## ENGINEERING CHANGE NOTICE

1 ECN 657602

13a Description of Change		13b Design Baseline Document? <input type="checkbox"/> Yes <input checked="" type="checkbox"/> No  Complete revision update of PFP Emergency Lighting Study, HNF-3178 No physical modification done to the facility, so no USQ required per PFP FSP 5-8, section 2 23		
14a Justification (mark one) Criteria Change <input type="checkbox"/> Design Improvement <input type="checkbox"/> Environmental <input type="checkbox"/> Facility Deactivation <input type="checkbox"/> As Found <input checked="" type="checkbox"/> Facilitate Const <input type="checkbox"/> Const Error/Omission <input type="checkbox"/> Design Error/Omission <input type="checkbox"/>				
14b Justification Details Backup and emergency lights in buildings 236 Z, 270 Z 2701 ZD, and 2705-Z were upgraded by ECNs 649762 and 649761 This ECN documents those changes in this document				
15 Distribution (include name MSIN and no of copies)

# PFP EMERGENCY LIGHTING STUDY

GROUP	1
BUILDING	234-5Z
LOCATION	Room 321
PRIORITY	1

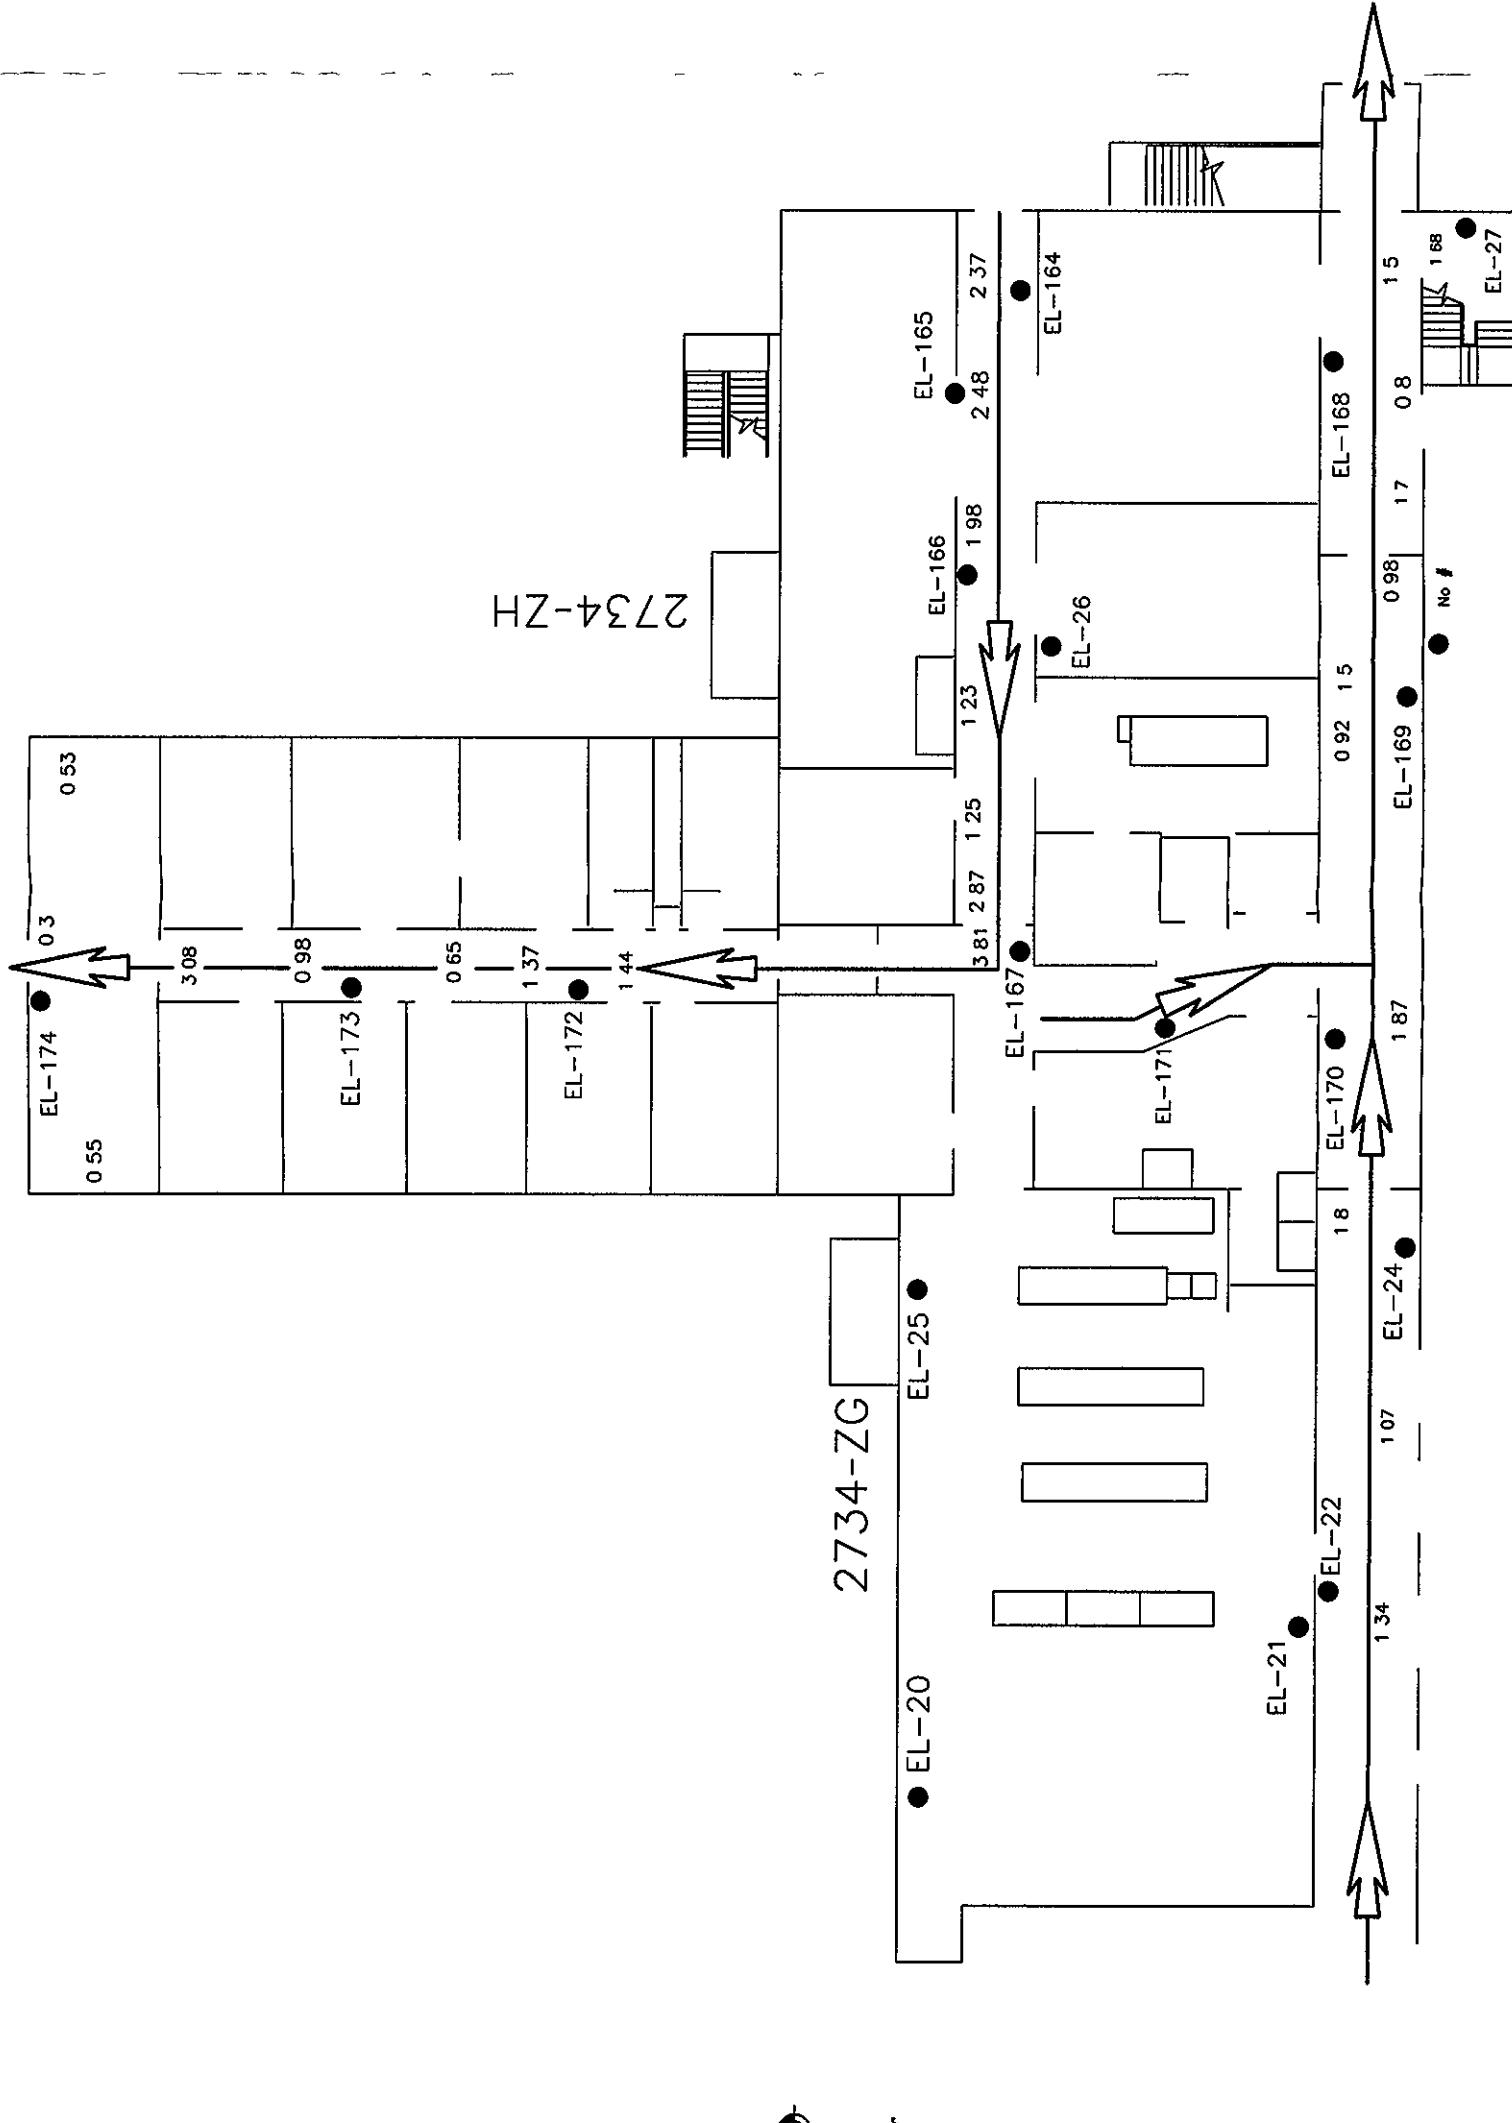
This area had no emergency light coverage and was completely dark during a normal lighting outage. Room 321 provides the only egress for the Control Room, which is manned 24 hours per day, 7 days a week. No other area had this high of an occupancy with such low emergency light levels. Additionally, Room 321 contains many safety hazards, including rotating machinery, bump and trip hazards, and a non-standard room configuration with smaller adjoining rooms and offices.

As shown in Appendix A, 10 Emergency Lights were added along the egress routes in this room under work package 97-1694. Light levels along the egress routes now measure about 0.5 footcandles. No further upgrades will be made to this room. The west roof emergency lighting was previously upgraded under Work Package 2Z-96-2410 to provide lighting from the Room 321 exit onto the west roof to the two ladders down the south walls.

GROUP	J
BUILDING	234-5Z
LOCATION	Stairs
PRIORITY	3

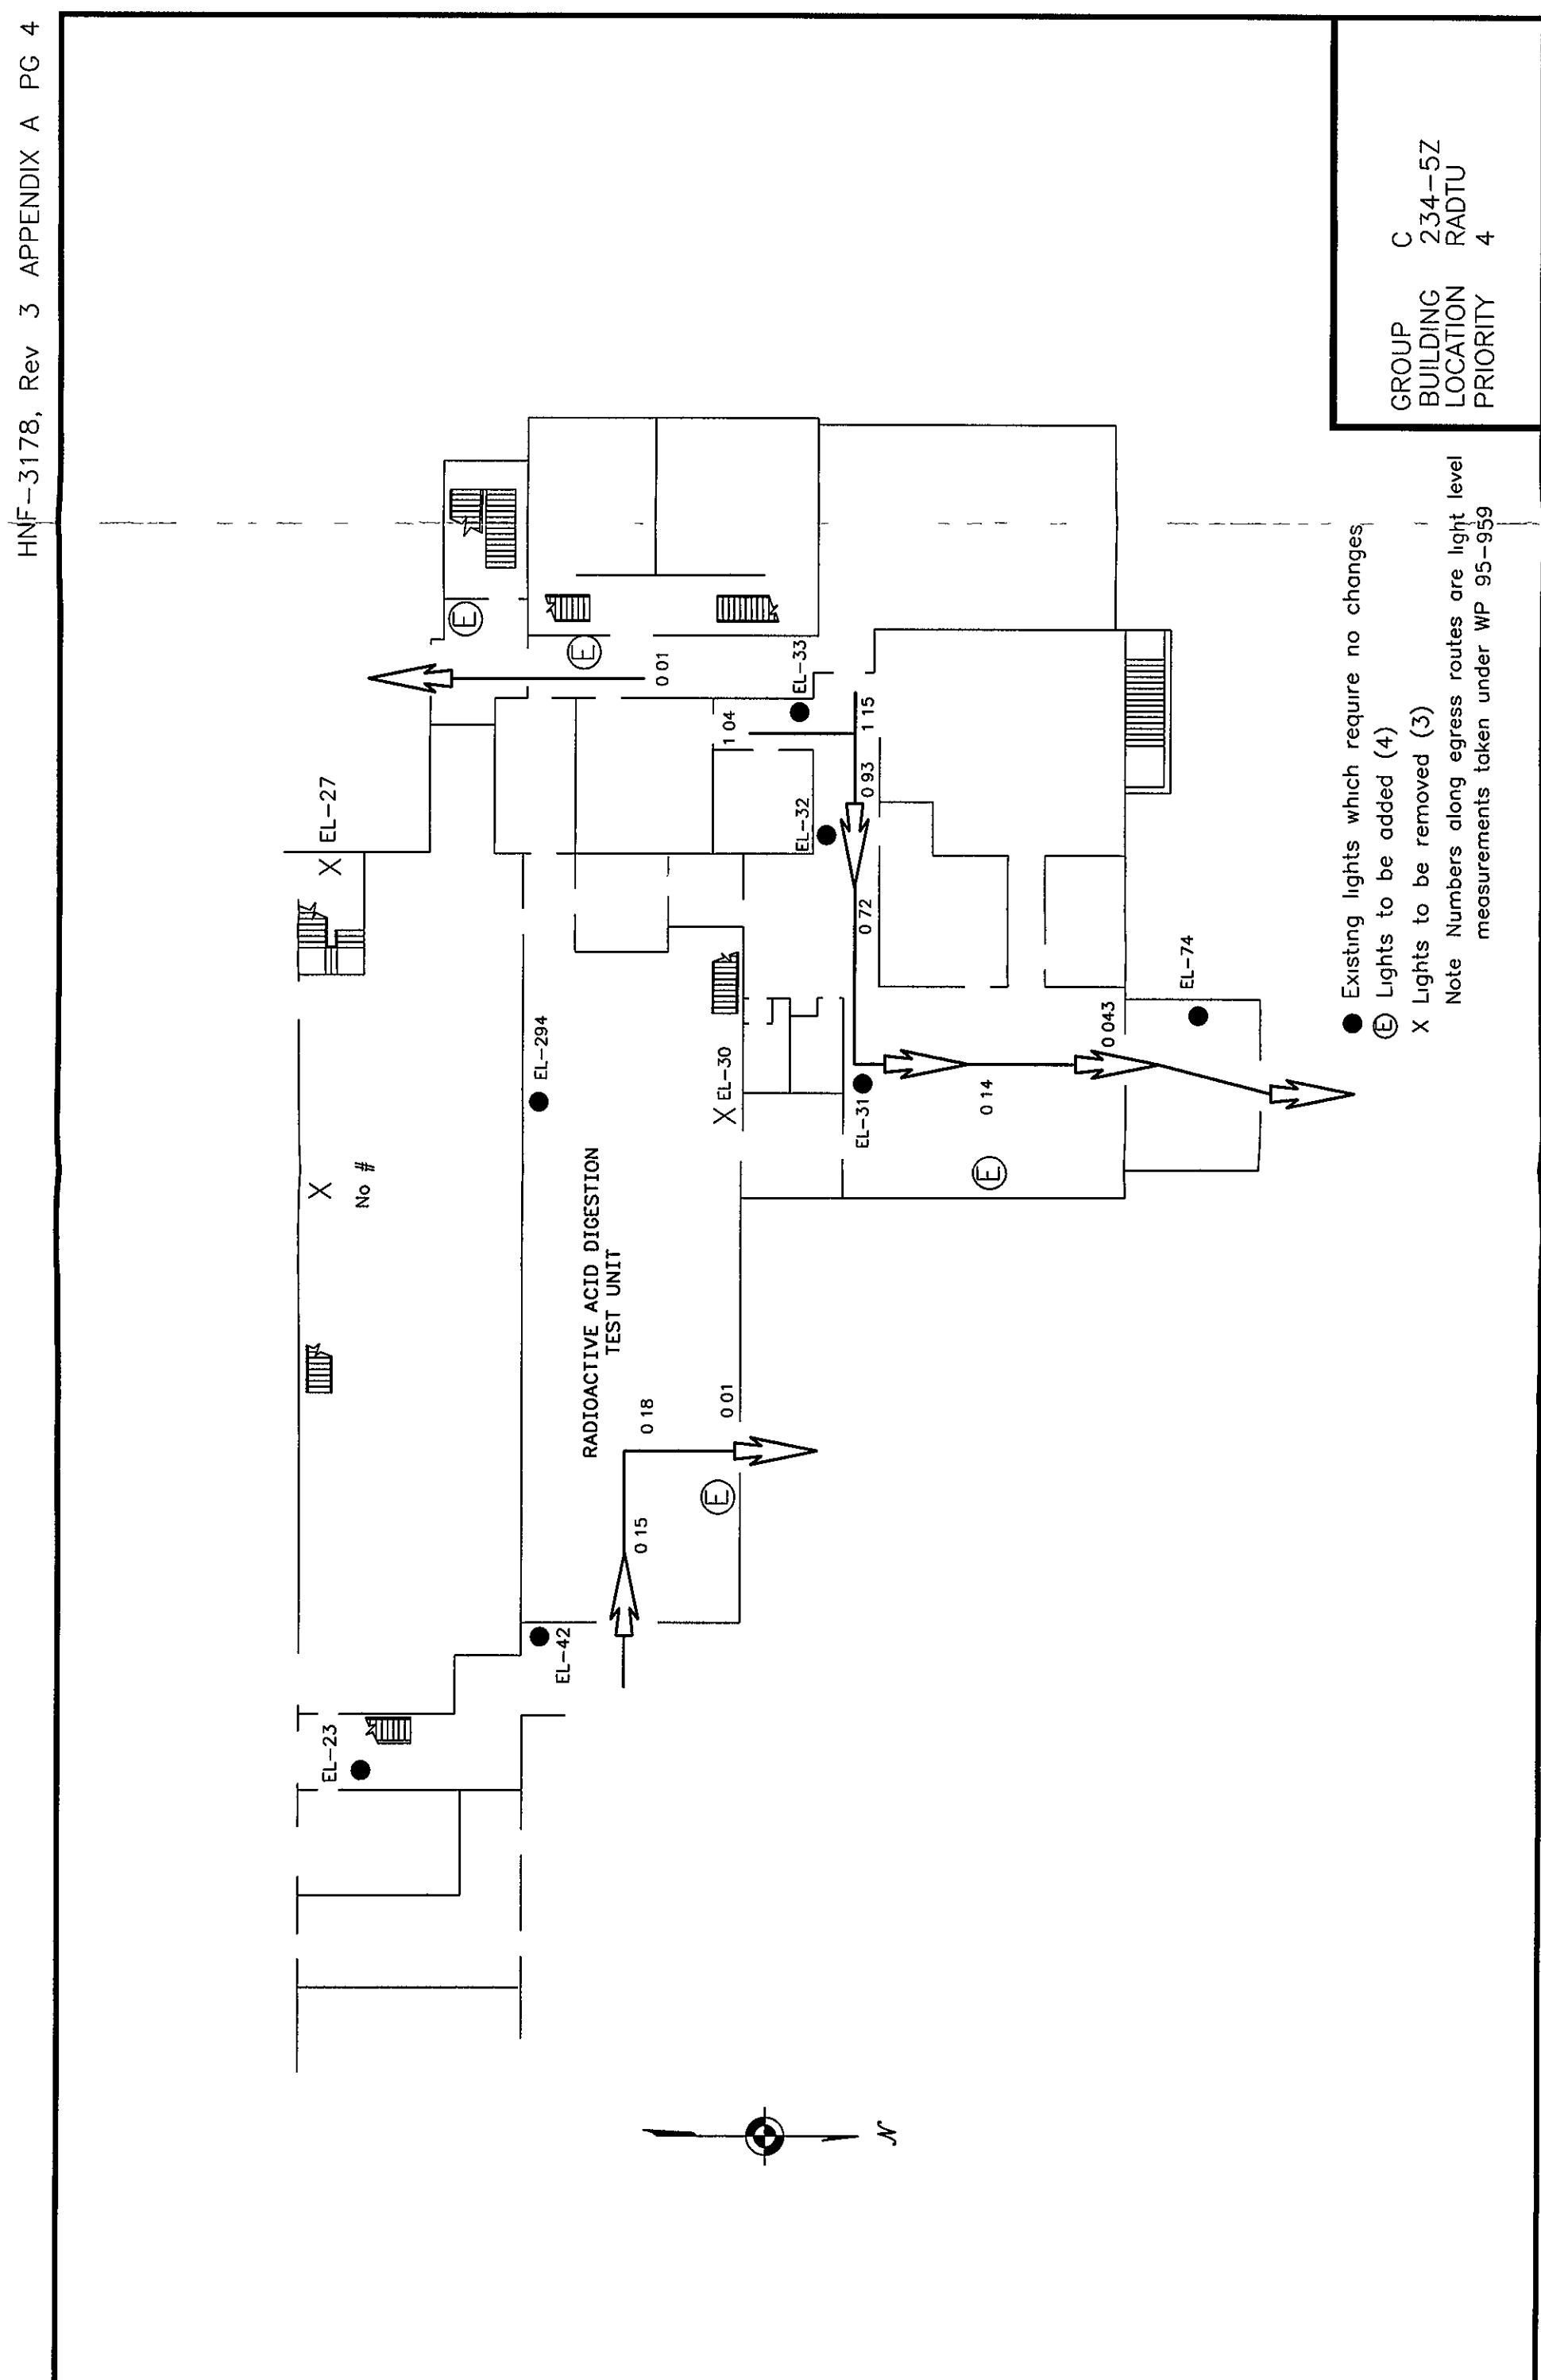
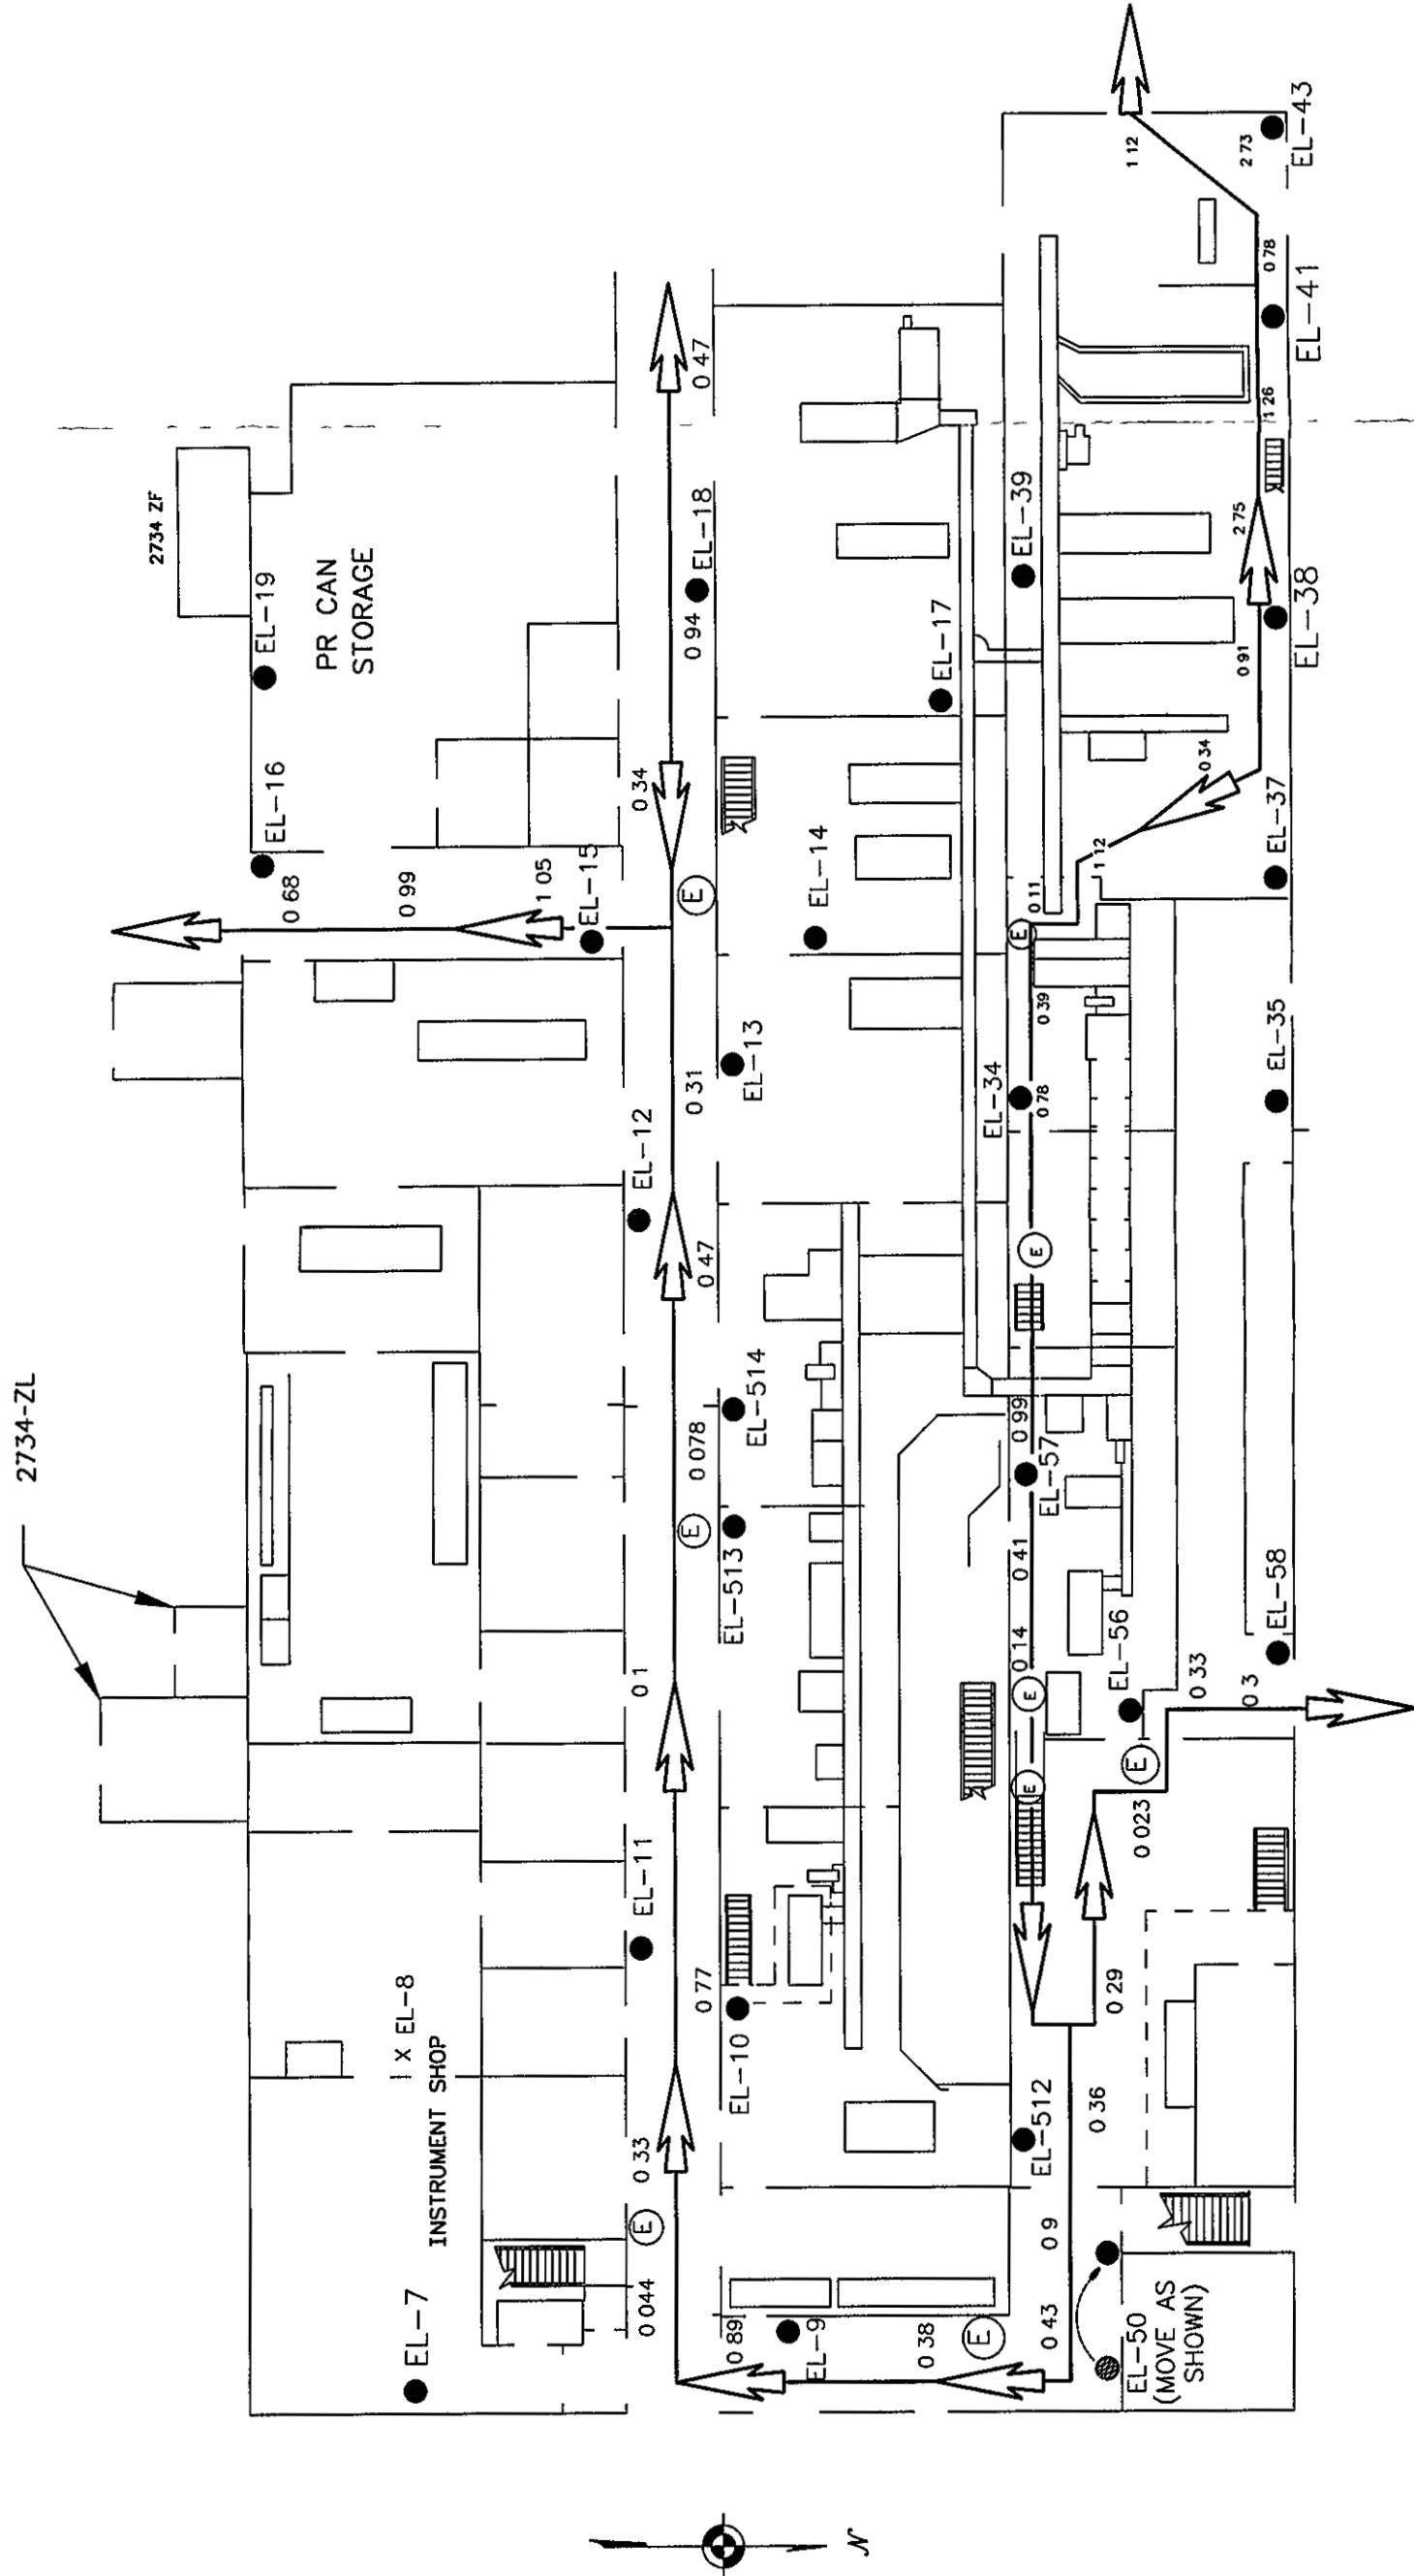
The stairs in building 234-5Z did not meet the NFPA requirements. Most had areas of low light levels, and some had flights with no emergency light coverage. These deficiencies represented significant trip and fall hazards during a lighting outage, especially during a building evacuation. The stairs are the only emergency egress routes available from the second floor and duct level. Since most stairs had at least some levels of emergency lighting, they were assigned a priority of three.

As shown in appendix A, 16 additional lights were installed in stairs under Work Package 2Z-98-1374 to raise the stair emergency light levels to NFPA requirements. The lighting level average for all the stairs now meet or exceed the NFPA requirements. Stair 6 was upgraded under a previous package and did not require any additional lighting.
